AMENDMENTS TO THE DRAWINGS

REMARKS

FIG.6

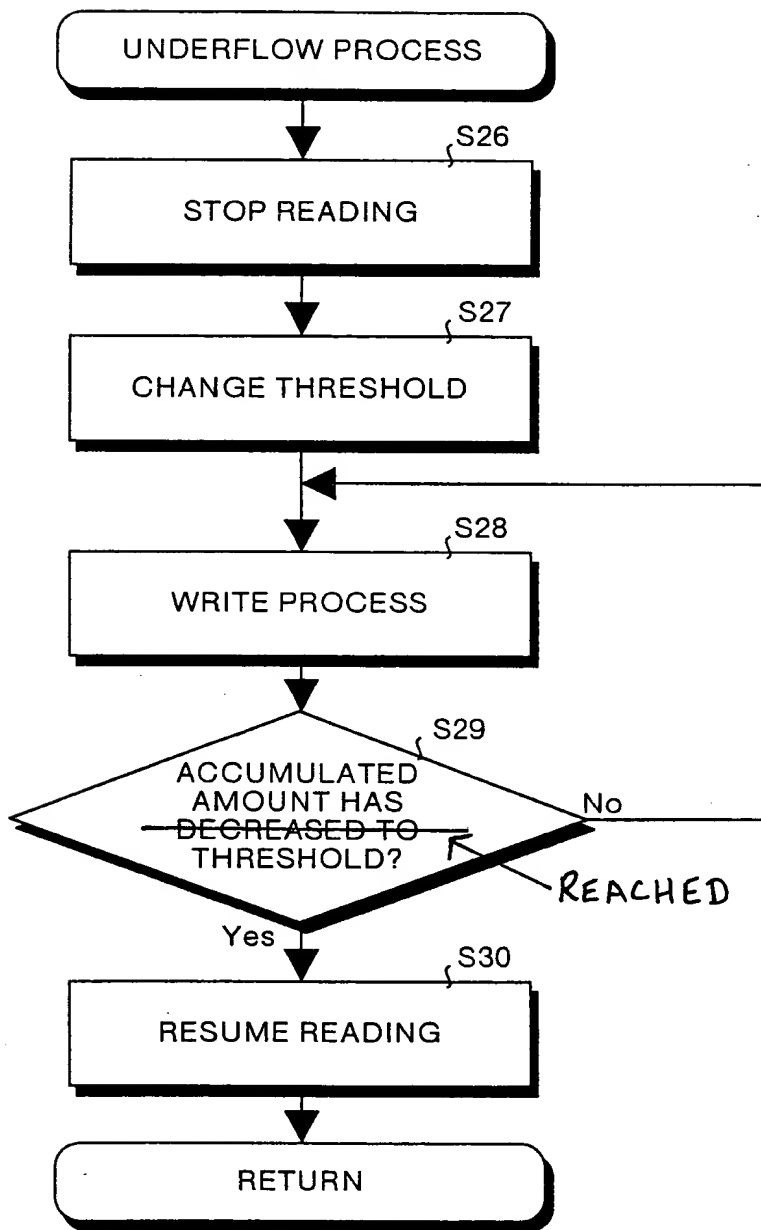
In Fig. 6, the caption "ACCUMULATED AMOUNT HAS DECREASED TO THRESHOLD?" in block S29 has been changed to "ACCUMULATED AMOUNT HAS REACHED ~~DECREASED TO~~ THRESHOLD?". In Figs. 26-30, the label "BACKGROUND ART" has been added.

Furthermore, the attached drawing corrections include a revision to Fig. 6 in which a typographical error has been corrected. Specifically, the caption in block S29 has been changed to "ACCUMULATED AMOUNT HAS REACHED ~~DECREASED~~ TO THRESHOLD?". It is respectfully submitted that this correction of Figure 6 does not add any new matter to the present applicant because it is fully supported in the specification at, e.g., page 53, lines 18-24.

FIG. 26
BACKGROUND ART

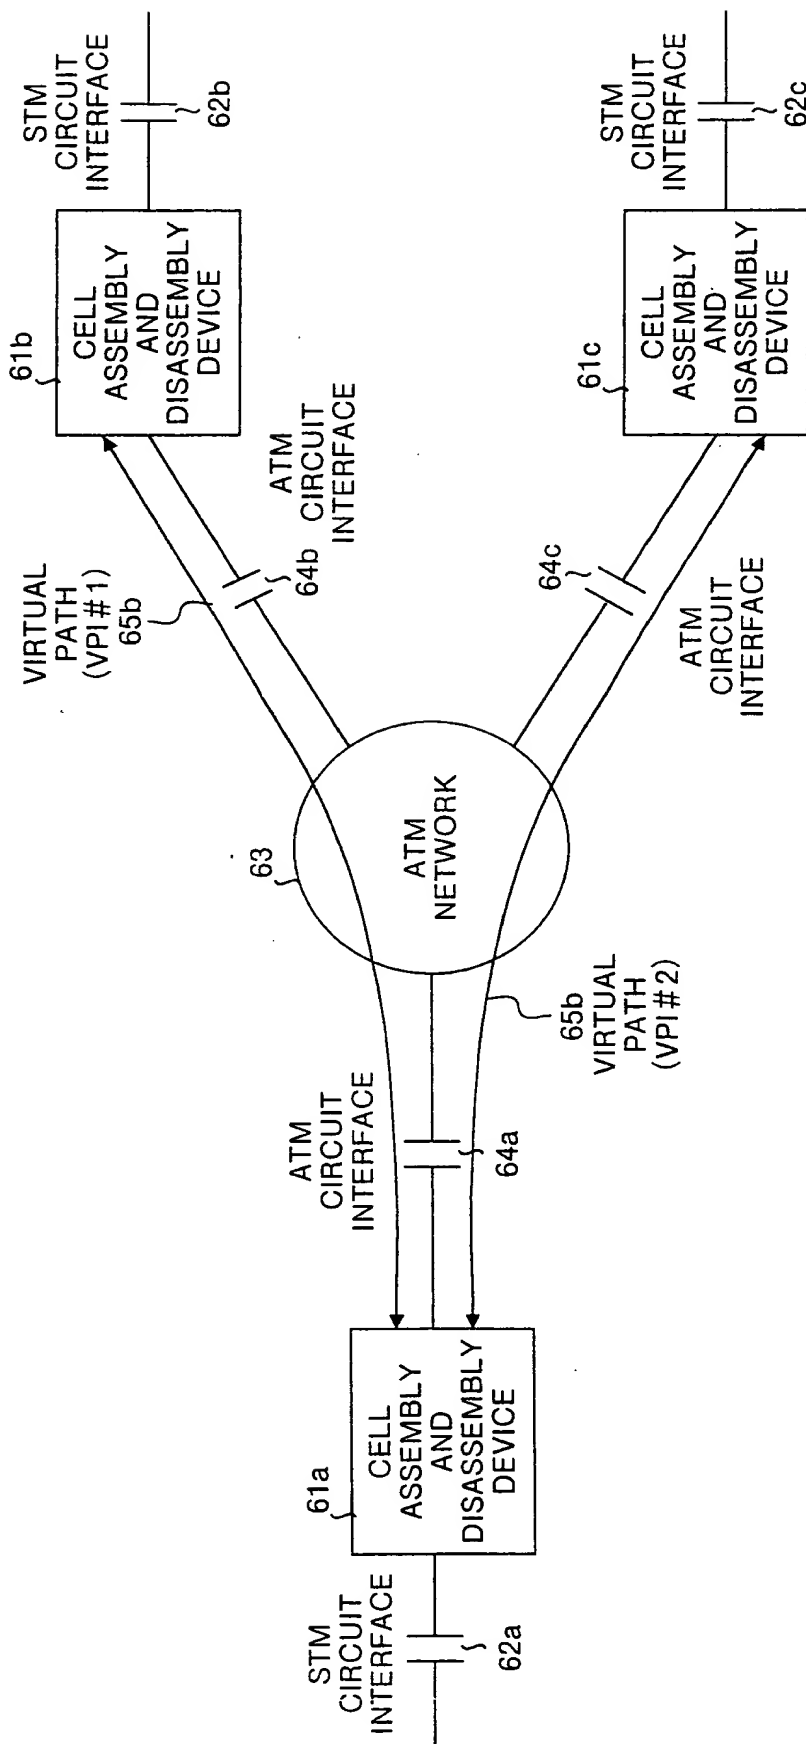
Attached herewith are drawing corrections in which Figs. 26-30 have been revised to include the legend "BACKGROUND ART" in response to the Examiner's objection to these figures.
